RE; Residential Development on land to the South of Doncaster Road, Darfield, Barnsley.
In joint application with Keepmoat Homes

Further to your recent email regarding comments from consultees on the above application we write to provide the following information:-

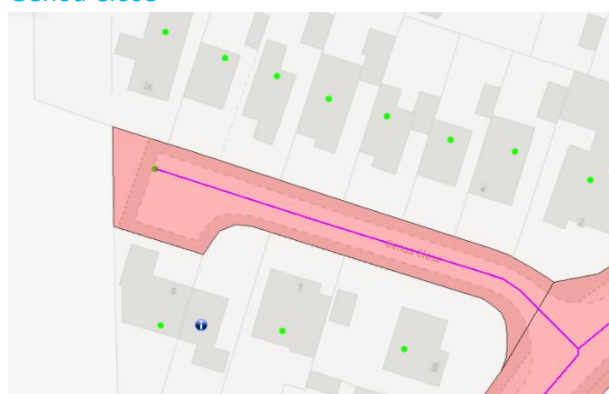
ATE seeks further information on how the development will achieve the indicated linkages along its eastern boundary to Belvedere Drive and Genoa Close which would shorten walking distances for some residents via Upperwood Road and/or the public footpath which abuts the primary school, while noting that these connections do not supplant the need to address the earlier concerns along Barnsley Road.

The carriageway and footpath adjacent the development site adopted is adopted by Barnsley Council, see extract below for extents of adoption. They directly adjoining the site ensuring pedestrian connection links are achievable.

Belvedere Drive

Genoa Close
